**DEFENSE NUCLEAR FACILITIES  
SAFETY BOARD**

## Staff Issue Report

February 18, 2016

**SUBJECT:** Waste Treatment and Immobilization Plant Quality Assurance Review

**Figures A-7 to A-8.** Staff review team photographs illustrating deficient storage conditions at the MHF Laydown Yard. Figure A-7 shows water accumulated inside a vessel. Figure A-8 shows additional pipe modules buried in the sand.

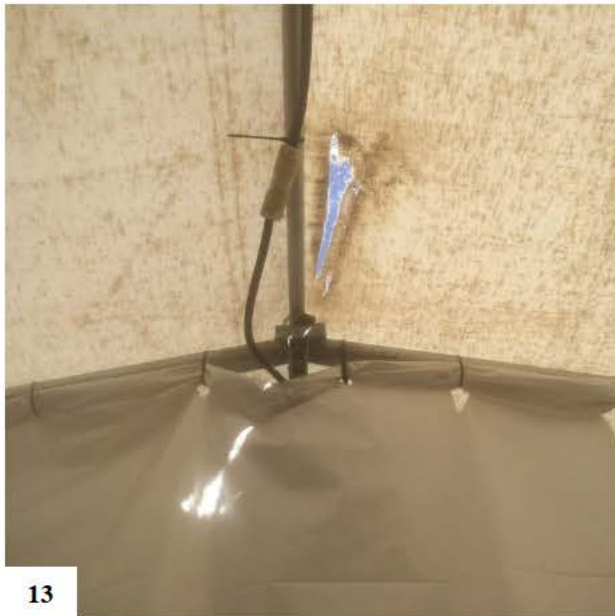
*Deficiency 1, SSC Storage at the MHF Laydown Yard*—In April 2015, at the MHF Laydown Yard, the staff photographed a substantial number of pipe spools and other SSCs buried in the sand and surrounded by excessive vegetation. Some SSCs were missing required protective coverings on their openings, and as a result, some SSCs showed signs of animal intrusion, contained standing water, or had a buildup of sand inside. See Appendix 1, Figures A-1 to A-8, for example photographs. These storage conditions are contrary to the following requirements:

Deficient storage conditions at the MHF Laydown Yard largely result from frequent high winds, blowing sand, and tumbleweeds, combined with inadequate corrective actions. BNI project procedure, *Field Material Inventory Management*, requires monthly surveillances of the MHF Laydown Yard. BNI assigned craft personnel to correct deficiencies identified during monthly surveillances; however, these efforts were not effective in maintaining compliant storage conditions. After receiving the staff review team’s agenda, BNI temporarily removed SSCs from rows 19 and 20, removed all sand, and leveled the ground. Appendix 1, Figures A-9 and A-10 illustrate BNI’s corrective actions. BNI also submitted a request for gravel to DOE-ORP. Pending approval, BNI expects the MHF Laydown Yard will be completely resurfaced with gravel within 2 years.

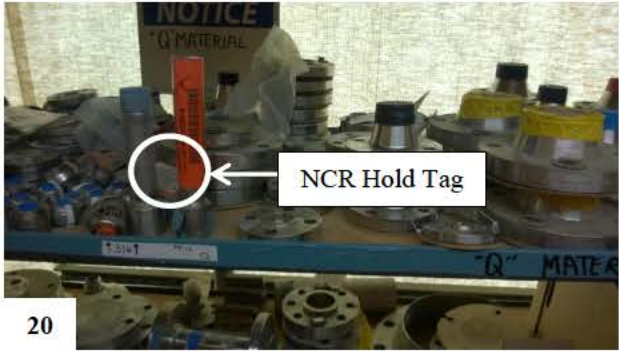
*Deficiency 2, Storage Tents*—In April 2015, , the staff photographed non-weathertight storage tents being used for “Level C Storage” at the MHF Laydown Yard and the WTP construction site. See Appendix 1, Figures A-11, A-12, and A-13, for example photographs. Some tents also showed evidence of animal intrusion. See Appendix 1, Figure A-14. These observed conditions are contrary to the following requirements:

Following receipt of the staff review team’s agenda, BNI performed an extent of condition for all Level C storage structures at the construction site. These structures included tents, small buildings, and trailers. BNI identified 10 structures requiring repairs and 8 structures that were less than adequate. BNI is relocating SSCs stored in deficient locations to warehouses. In addition, BNI will no longer designate storage tents located at the MHF Laydown Yard as Level C storage, unless they are repaired.
